Replacement Requirement for 22 kW High-Voltage Charger - OBC (240/24)

Model Year: **As of 2020 up to 2024**

Model Line: **Taycan (Y1A/Y1B/Y1C)**

Equipment: **22 kW high-voltage charger (M-no. KB4)**

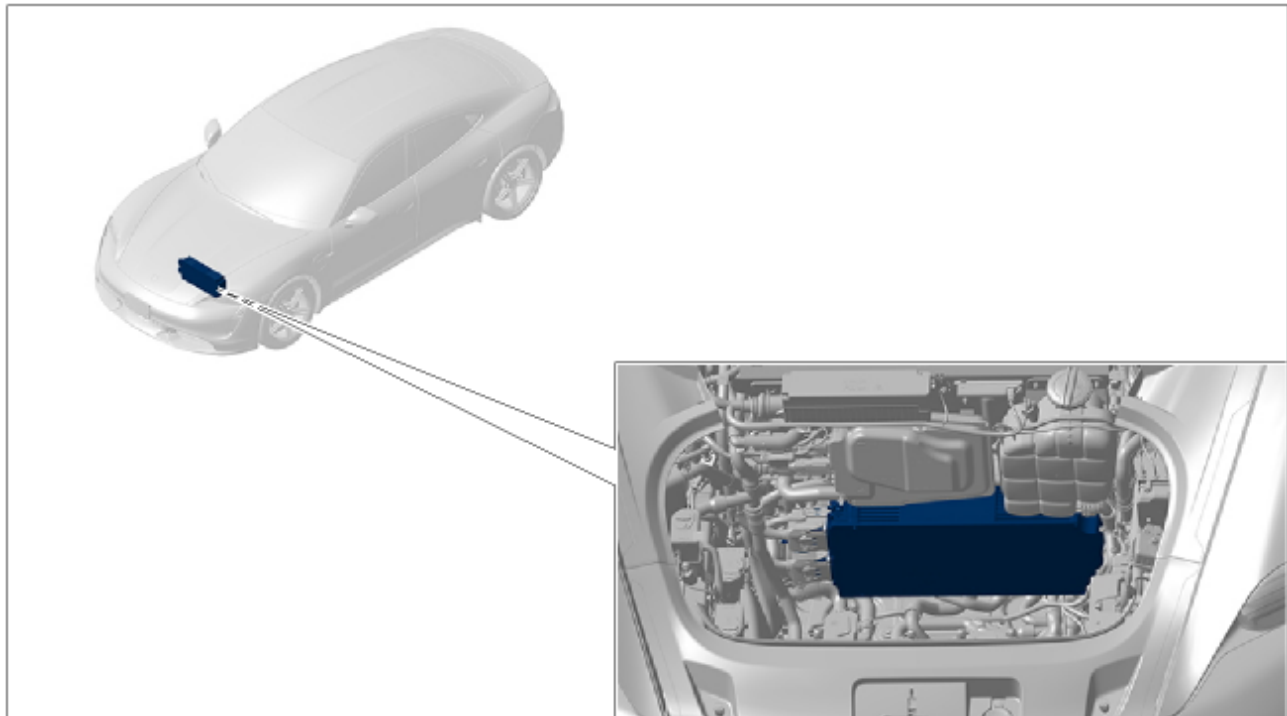
Cause: **22kW OBC service part for 2020–2024 Taycan is no longer available. If replacement is necessary, please install an 11 kW replacement OBC and notify the customer as instructed below.**

Action: If there is a need for replacement, **replace the previous 22 kW high-voltage charger (OBC) with a 11 kW high-voltage charger (OBC).**

Previous Lower Bracket Holders

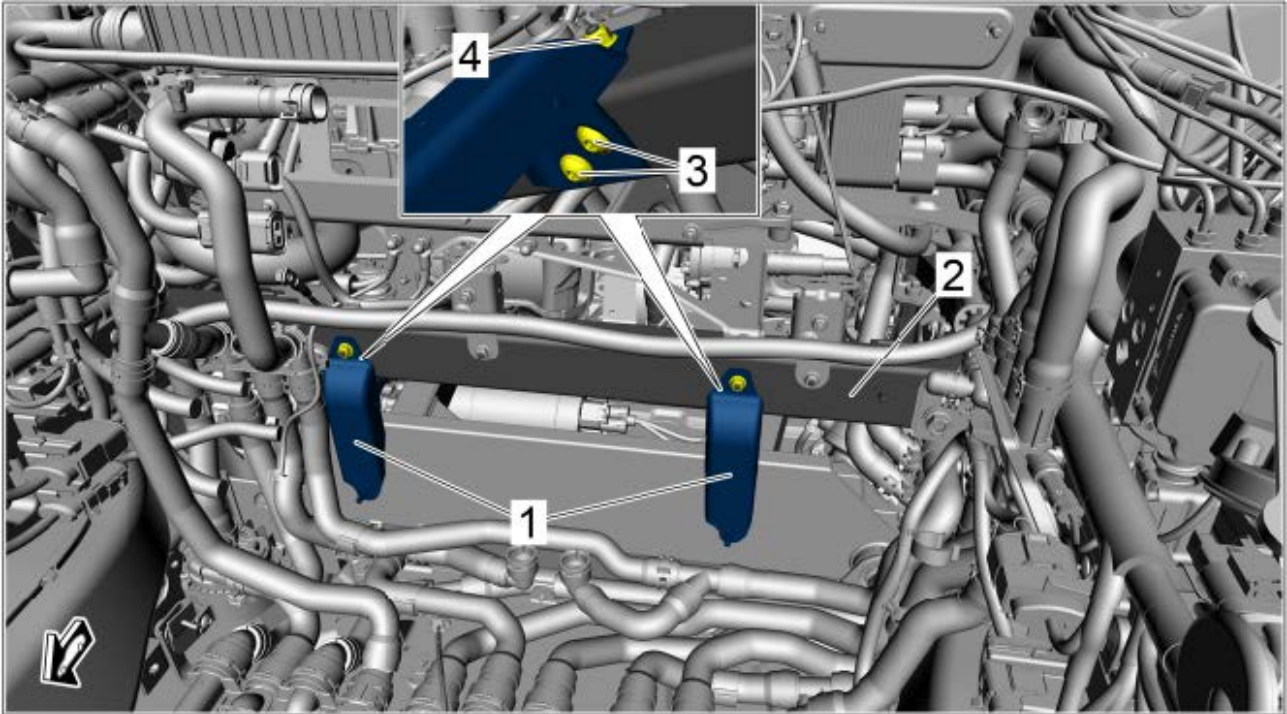
- Work Procedure: 1 Remove both previous lower bracket holders ⇒ Previous Lower Bracket Holders -1- by unscrewing screws ⇒ Previous Lower Bracket Holders -2- and ⇒ Previous Lower Bracket Holders -3- nuts. The previous lower bracket holders ⇒ Previous Lower Bracket Holders -1- can be disposed of; they are no longer required.

New Lower Bracket Holders

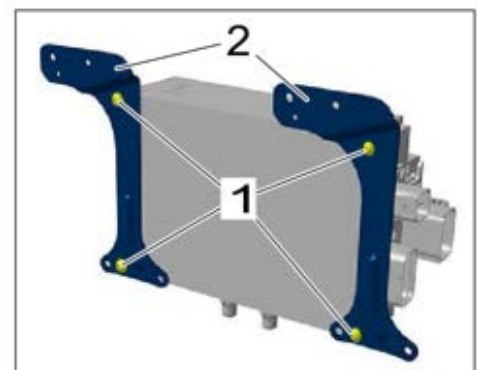
- 2 Install **new** lower bracket holders ⇒ *New Lower Bracket Holders -1-*.

- 2.1 Position **new** lower bracket holders ⇒ *New Lower Bracket Holders -1-* on the cross member ⇒ *New Lower Bracket Holders -2-*.
Make sure that the position of the lower bracket holder on the left in the direction of travel moves to the middle position.
- 2.2 Fit and tighten **new** screws ⇒ *New Lower Bracket Holders -3-* and **new** nuts ⇒ *New Lower Bracket Holders -4-* on the **new** lower bracket holders ⇒ *New Lower Bracket Holders -1-*.

Tightening torque 8 Nm (5.9 ftlb.)

Convert high-voltage charger holder

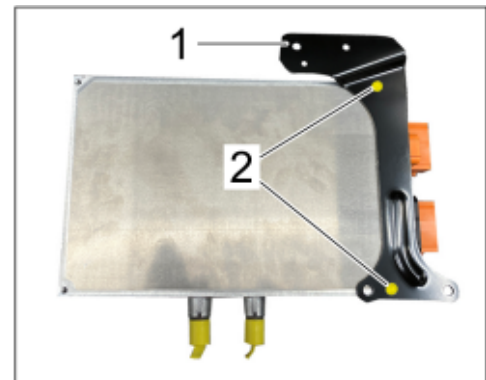
Work Procedure: 1 Convert **previous** plug-side holder $\Rightarrow$ Convert **high-voltage charger holder -1-** from **previous** 22 kW high-voltage charger to **new** 11 kW high-voltage charger.

1.1 Thread-off screws $\Rightarrow$ Convert **high-voltage charger holder -2-**.

1.2 Remove holder $\Rightarrow$ Convert **high-voltage charger holder -1-** and position on **new** 11-kW high-voltage charger. $\Rightarrow$ Install **high-voltage charger holder**

1.3 Screw-in and tighten **new** screws $\Rightarrow$ Install **high-voltage charger holder -2-**.

Tightening torque 8 Nm (5.9 ftlb.)

Install high-voltage charger holder

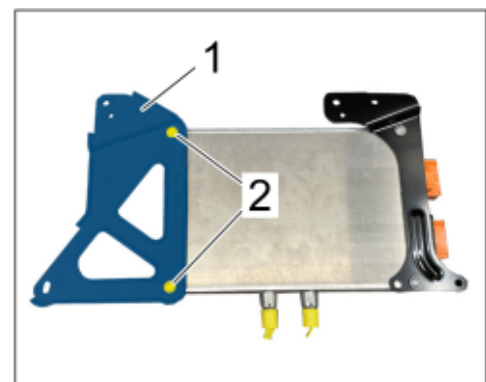
2 Fasten **new** high-voltage charger holder $\Rightarrow$ New **high-voltage charger holder -1-** to the **new** 11 kW high-voltage charger.

2.1 Position **new** high-voltage charger holder $\Rightarrow$ New **high-voltage charger holder -1-** on **new** 11-kW high-voltage charger.

2.2 Screw-in and tighten **new** screws $\Rightarrow$ New **high-voltage charger holder -2-**.

Tightening torque 8 Nm (5.9 ftlb.)
